Product Change Notice

To: All concerned
 From: Jose Ignacio Álava
 Date: March 25, 2021
 No. of pages: 1
 PCN-Ref. No.: New housing design for the PT10 and PTC10 serie / [rev. 1](#)

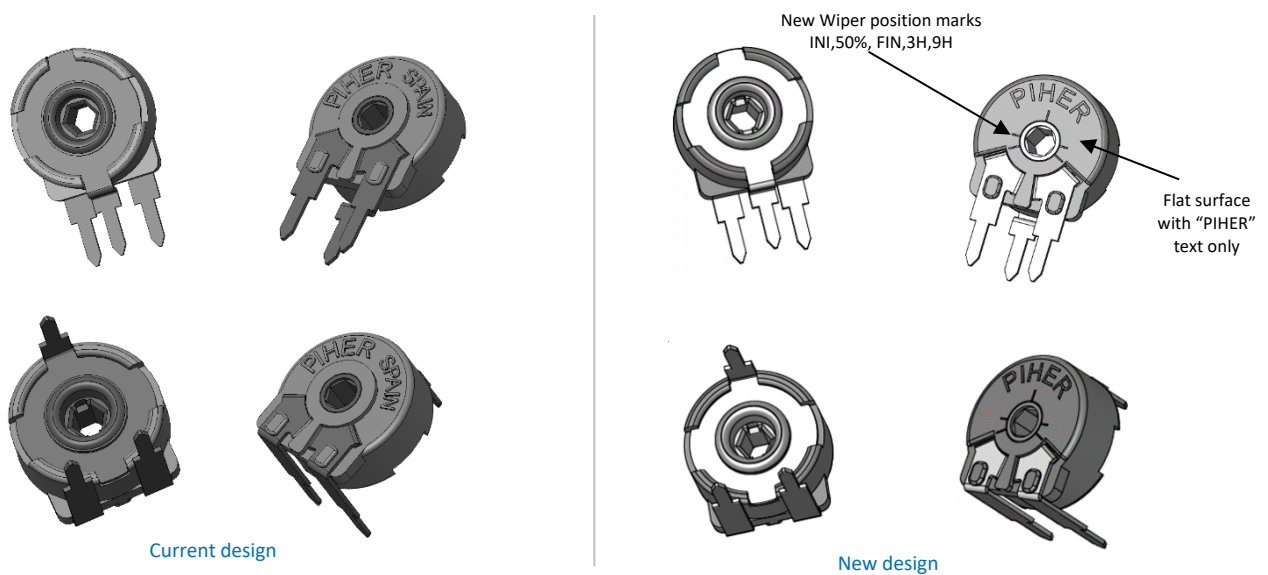
Please be advised that we are upgrading the housing design for the PT10 and PTC10 potentiometer series. This cosmetic change is *backward compatible* with the current tooling design and it is including rotor position marks in the front and having a flat front surface with "PIHER" text instead of "PIHER SPAIN".

Mechanical and electrical specifications remain unchanged.
